**FINAL ENVIRONMENTAL IMPACT REPORT AND
SUPPORTING DOCUMENTATION**

RANCHO SANTA FE ROUNDABOUTS PROJECT

County Project No. 1009758

- List of Commenters, Letters of Comment, and Responses to Comments on the Draft Environmental Impact Report

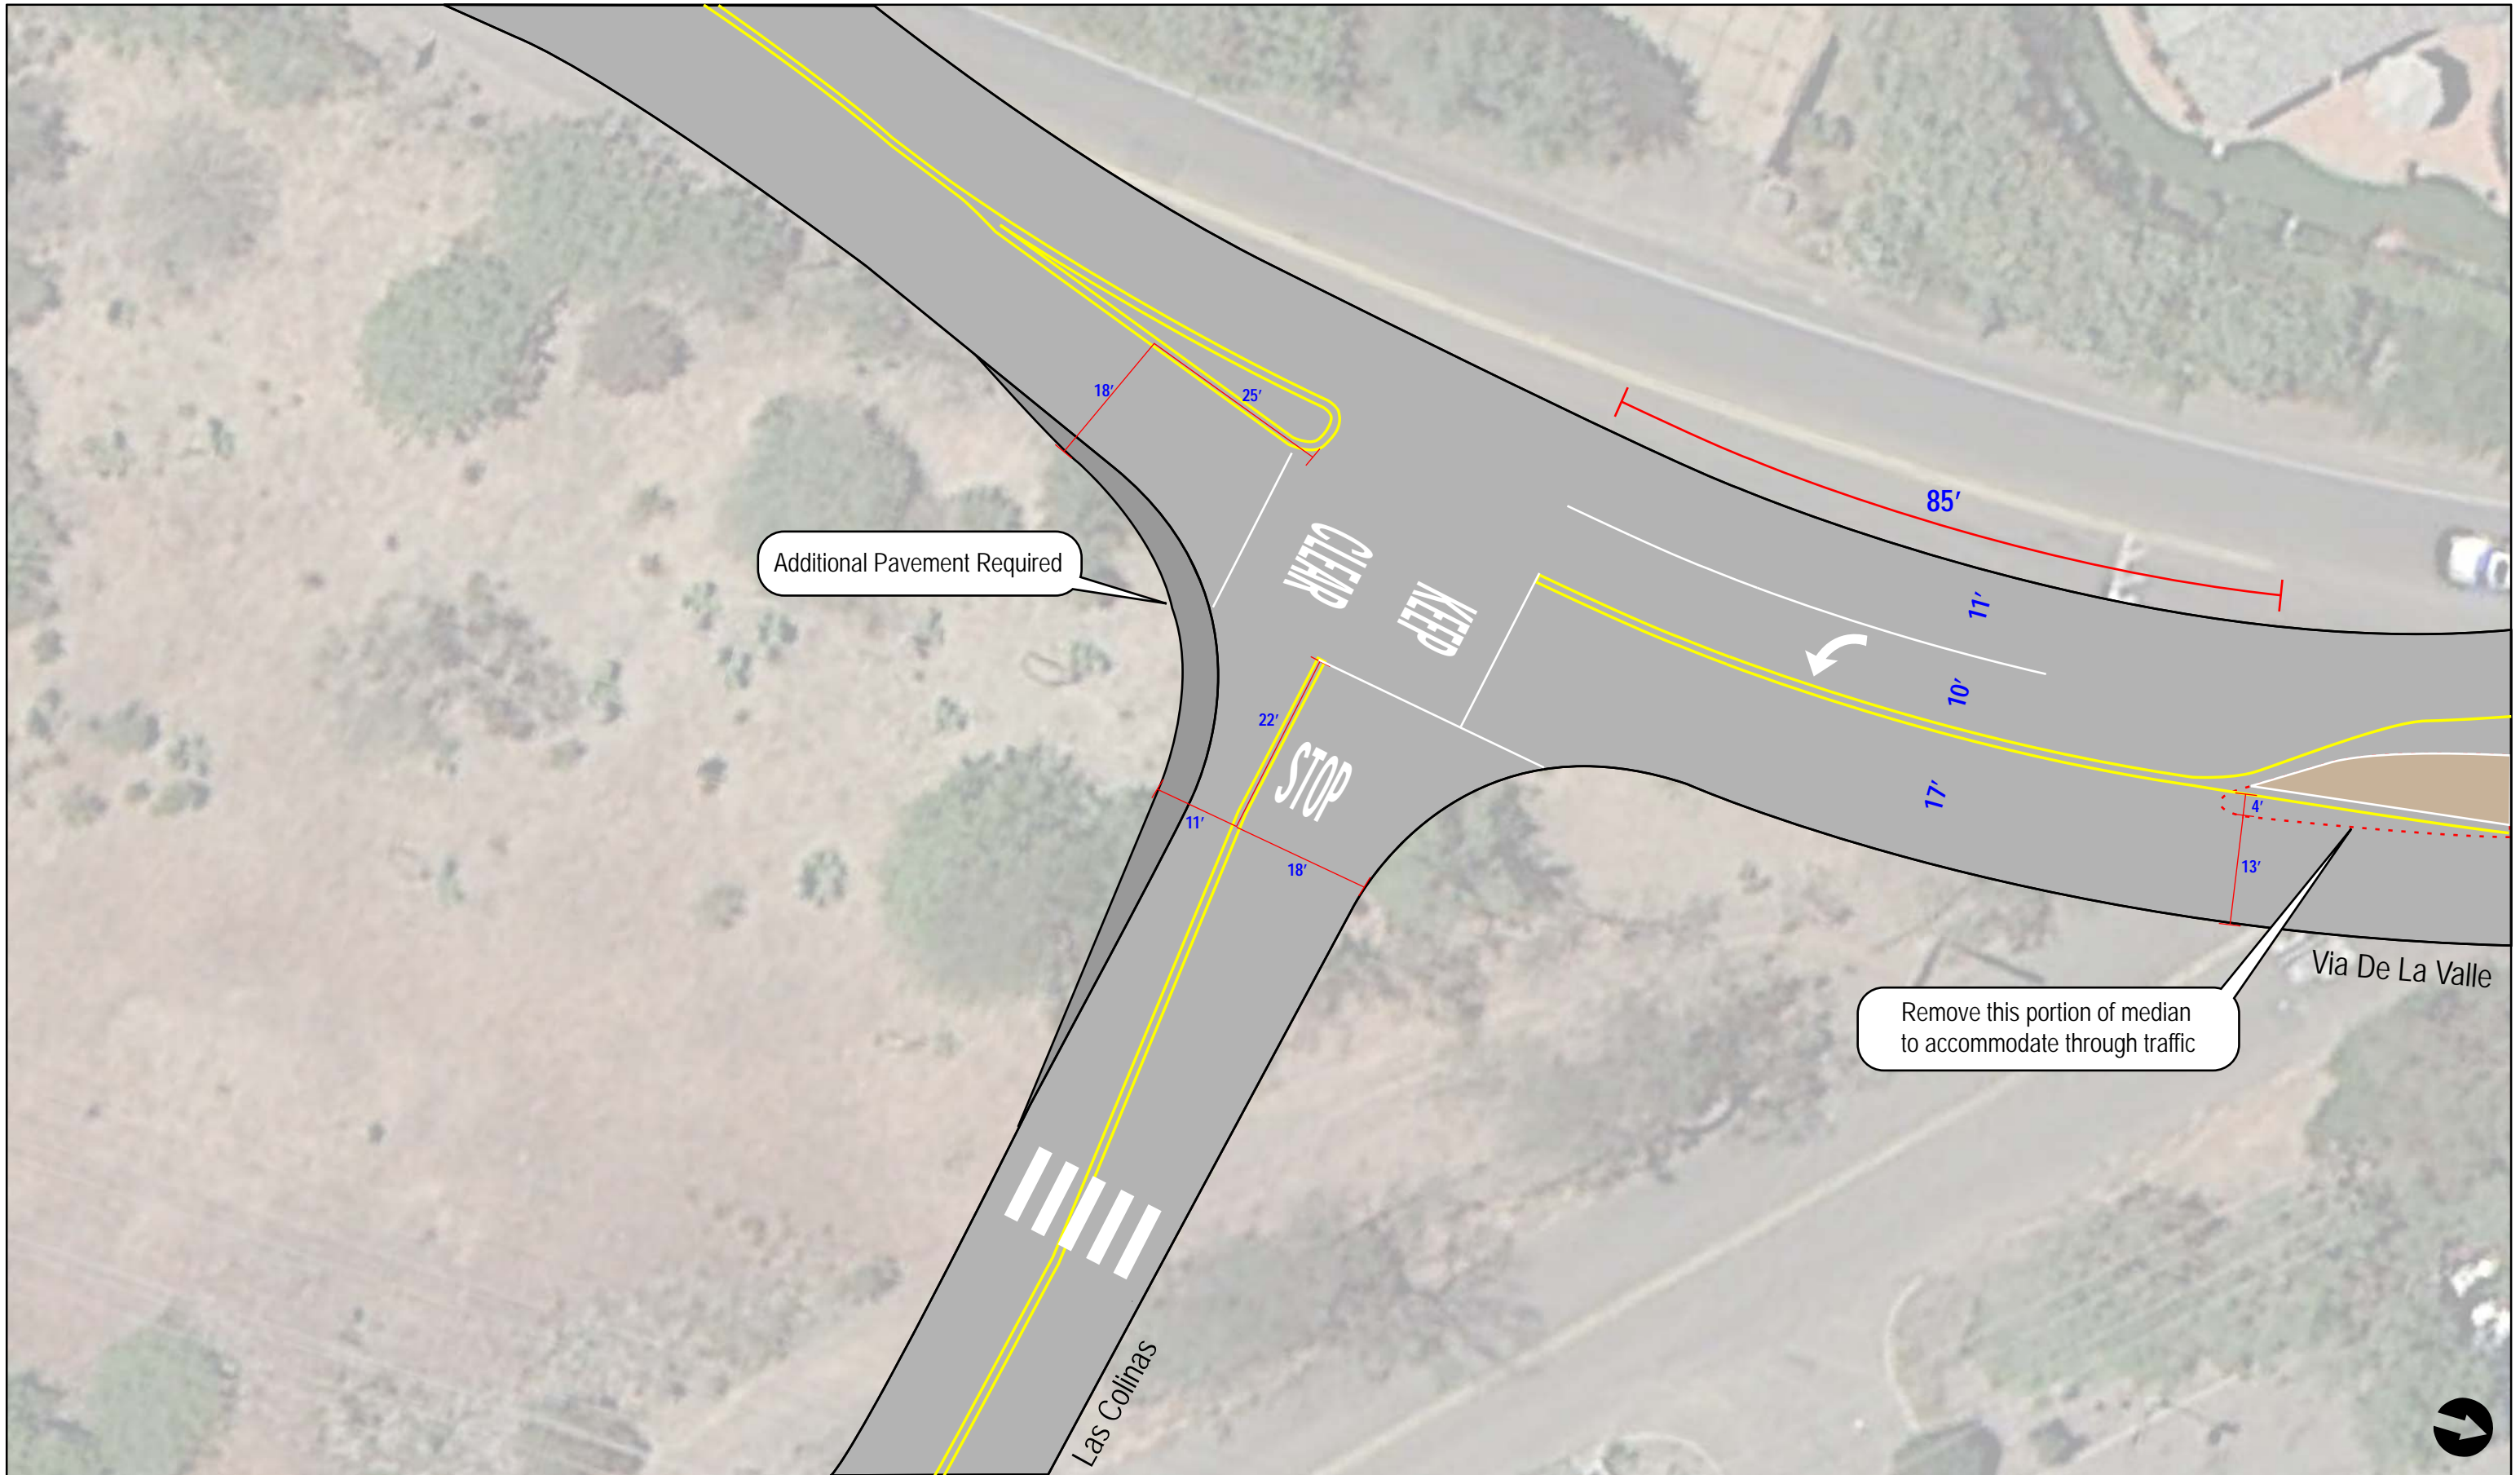
- A dedicated southbound left-turn on Via de la Valle will improve ingress to Las Colinas in the southbound direction. As depicted in Figure 1, with the proposed improvements, a storage length of about 85 feet will be provided for the left turn. Based on the projected traffic volumes, this proposed storage length is more than required. It should be noted that the available storage length increased from about 40 ft in the previous conceptual plan to 85 ft in

the current proposed plan. The increase is due to the extension of the left turn lane to accommodate the “Keep Clear” pavement marking and the sneaker lane.

- Q-8** The County appreciates this comment. The existing Keep Clear pavement markings on Via de la Valle at the Las Colinas entry to Via de la Valle were inadvertently omitted from the project design plans and the EIR. Please see Figure 1 of Supplemental Appendix M-3 (Traffic Analysis – Via de la Valle/Las Colinas Intersection Improvements), which identifies the “keep clear” zone.

Figure 1.4
Paseo Delicias/Via de la Valle/La Fremontia Intersection

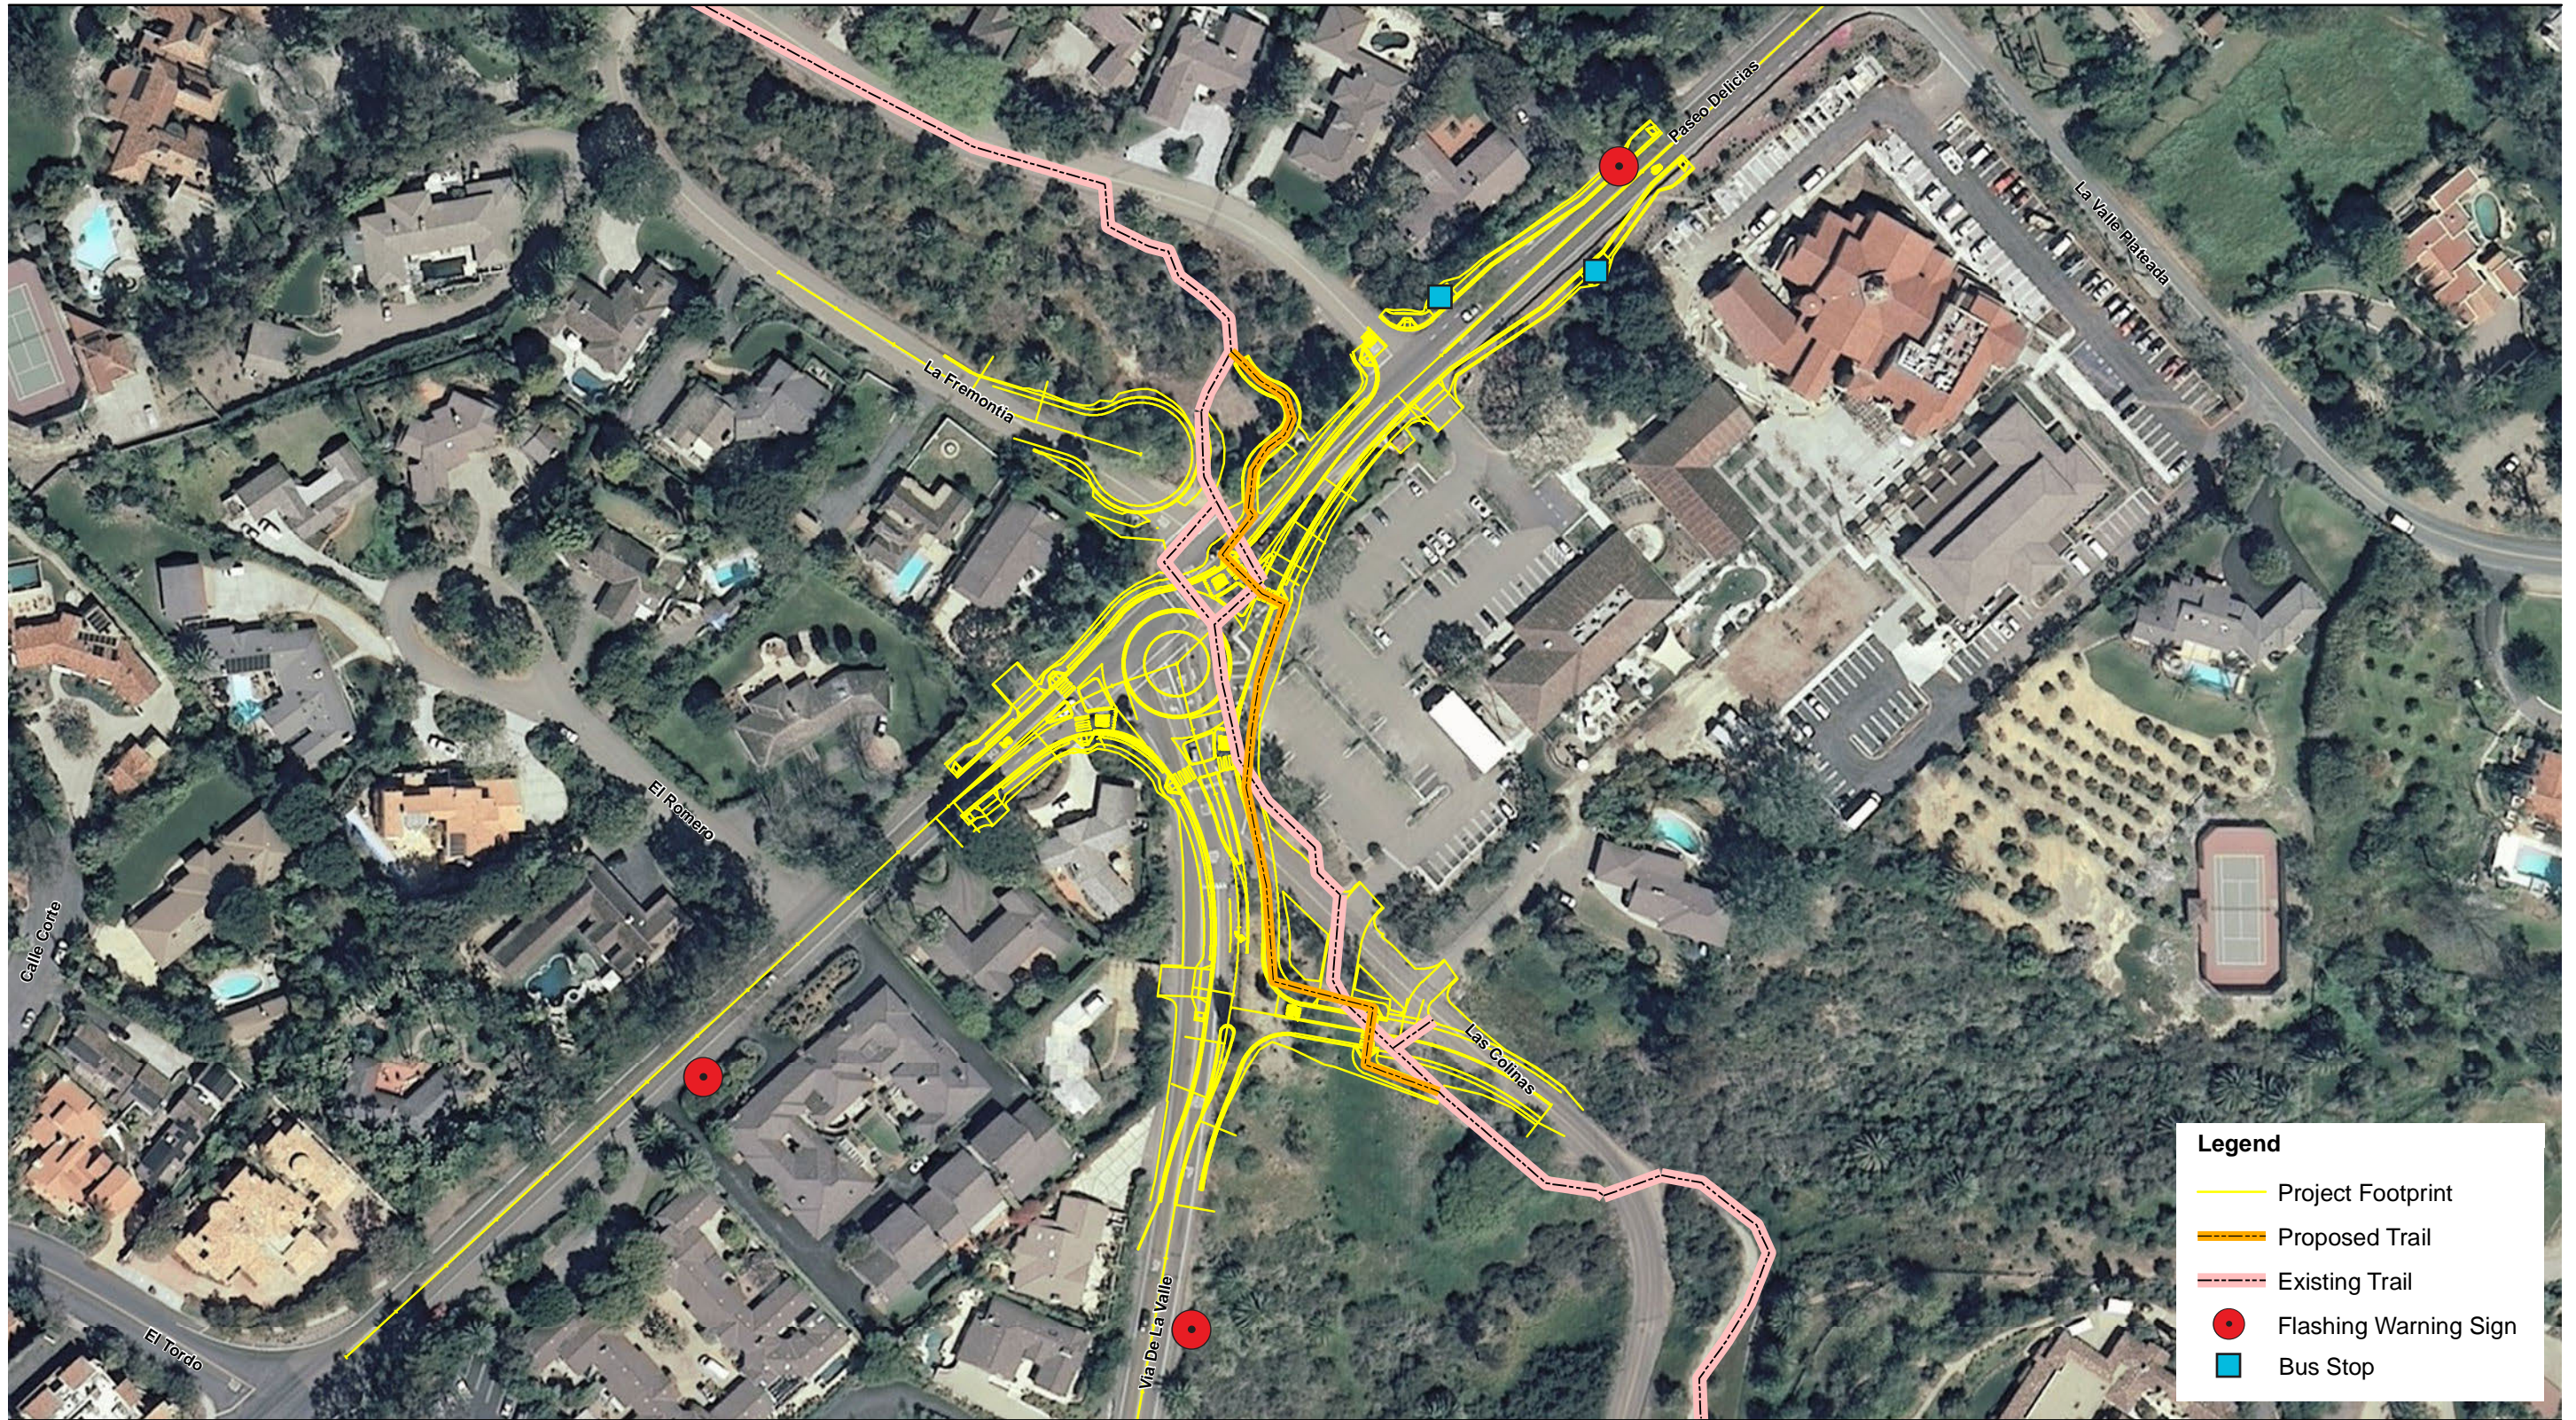
- F-5 Fig 1.4, p. 47. Via de la Valle/Paseo Delicias/Las Colinas:
 - 1. Please add Pedestrian/Equestrian push-button activated LED-lit crosswalk on Las Colinas. Reason: Shorter sight distance and higher speed will be enabled due to realignment of Las Colinas. This signal pole does not need to be linked to the poles for the intersection Via de la Valle/Paseo Delicias.

- F-7 3. Drawing needs to show the left-turn pockets at Las Colinas and Paseo Delicias.
- F-8 Fig 1.5, p. 49. Paseo Delicias/EI Montevideo/La Valle Plateada: A desired trail should be shown in right-of-way (ROW) along NE side of EI Montevideo (Bunn property) - we have ridden there for decades. It could be shown as a dashed pink line. This trail connects trails to the north on EI Montevideo.

crossing at Las Colinas is identified on the project plan sheets (Sheet SN2) included as Appendix M to the Traffic Impact Analysis, Appendix D to the EIR. No changes were made to the EIR as a result of this comment.

- F-7** The commenter requests that the drawing show the left-turn pockets at Las Colinas and Paseo Delicias. There is no intersection of Las Colinas and Paseo Delicias; as such, the County is not sure which intersection(s) the commenter is referring to. In an attempt to address the comment, the left turn pocket from westbound Via de la Valle onto Las Colinas is identified on the plan sheets (Sheets ST1 and ST2 in Appendix M to the Traffic Impact Analysis, Appendix D to the EIR). No changes were made to the EIR as a result of this comment.
